# Opel Corsa D - Chirping noise coming from the engine compartment | HELLA

**Chirping noise coming from the engine compartment.**

Picture 1

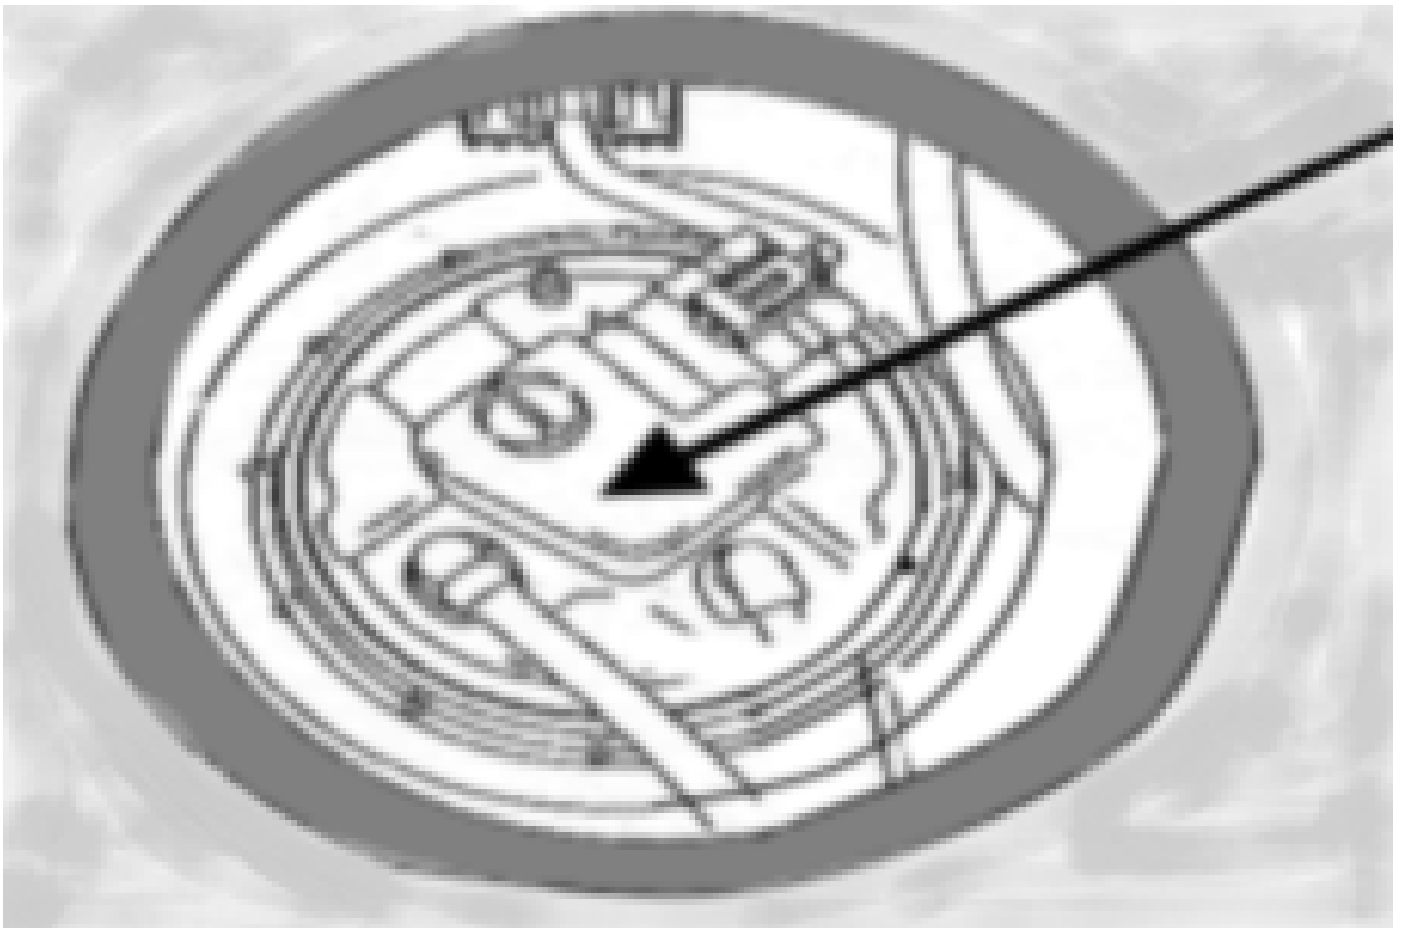
With these vehicles, the fuel pump to be installed should have 13252214 as its production number (Spare part no.: 93190773) (For position of the part number see arrow / Illustration 1). If the fuel pump having the production number 13252213 has been installed, this is to be replaced.

- Lift up felt covering / service cover (see picture 1).
- Check the part number of the fuel pump and, if necessary, replace the fuel pump and the sealing ring.
- Check the part number of the fuel line and replace if necessary.

Even if the correct fuel pump has been installed, the fuel return line is also to be checked. This could be an additional source of the noise development (Spare part no.: 55565103) and should be exchanged for another fuel return line (Spare part no.: 5583597) in order to remove and rectify this second possible cause of generating noise in the engine.
